1989 - 1990 Corvette: Service Bulletin: Convertible: Mounting Bracket Rattle at Rear of Hardtop

Number: 90-203-10

Subject: Mounting Bracket Rattle at Rear of Hardtop

Model Year: 1989-1990 Y Car Convertible

CORVETTE HARDTOP
BRACKET REAR PIN MOUNTING R/L
 (SERVICE PROCEDURE)

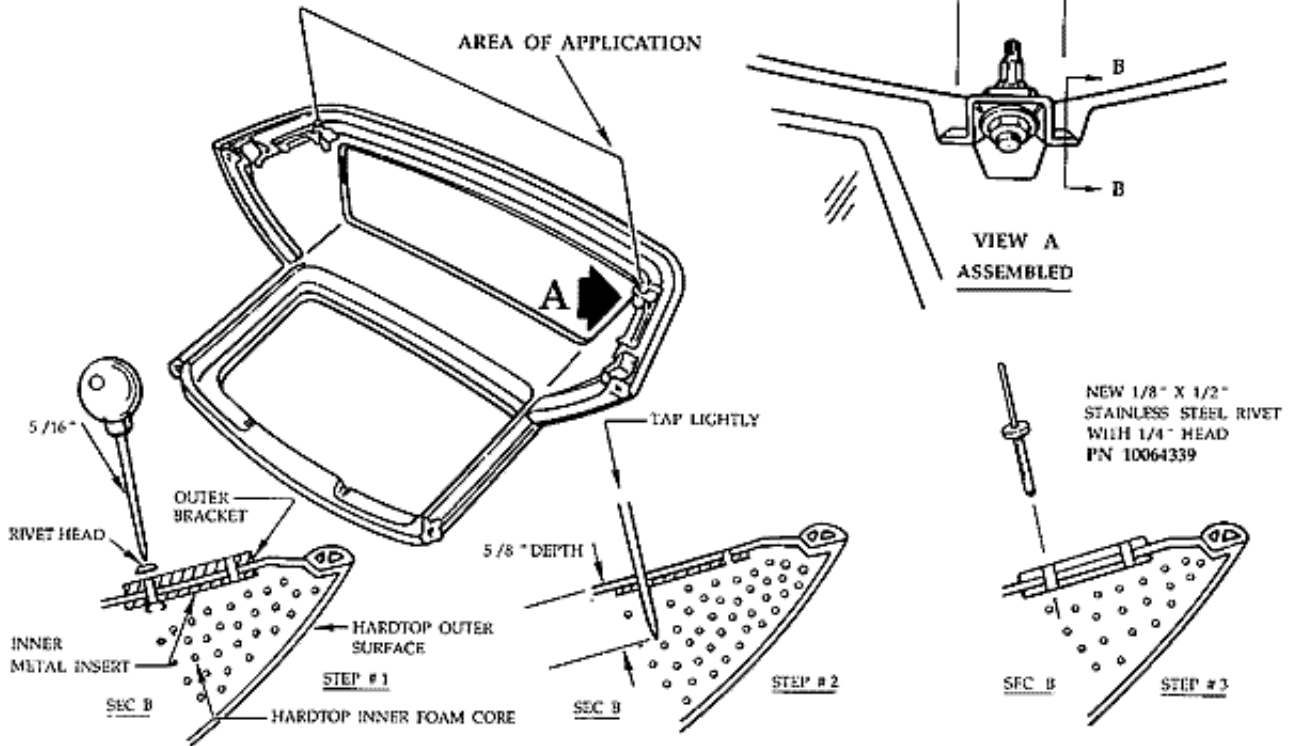
Some 1989 and early 1990 Chevrolet Corvettes (before VIN 106253) equipped with the convertible hardtop option (CC2) may exhibit a rattle at the rear of the hardtop caused by loose hardtop mounting brackets.

Some of these brackets were mounted with rivets which were not long enough to provide enough retention to prevent the rattle.

- STEP #1 DRILL OFF RIVET HEADS, USING A 5/16" DRILL BIT, AND REMOVE BRACKET. (4 RIVETS PER ASM.)
- STEP #2 TAP PREVIOUS RIVET BODIES AND MANDREL 5/8" DOWN INTO HARDTOP INNER FOAM CORE AREA. (4 RIVETS)
- STEP #3 REPOSITION BRACKET AND RE-ATTACH USING NEW RIVET (PN 10064339)

1. Remove hardtop assembly as outlined in the Service Manual.
2. Place the hardtop assembly upside down on a clean protective surface.
3. Using a 5/16 in. carbide tip drill bit and a DRILL STOP SET AT 1/2 INCH, drill the heads off of the four rivets holding the bracket to the hardtop assembly.

4. Using a hammer and a nail or small punch, lightly tap the old rivet bodies into the foam core of the hardtop. The rivets should be driven about 5/8 inch into the foam core.

5. Install new stainless steel rivets, P/N 10064339 to secure the bracket. Part is currently available from GMSPO.
6. Repeat steps 3 through 5 for opposite side of the hardtop assembly.
7. Reinstall roof assembly as outlined in the Service Manual.
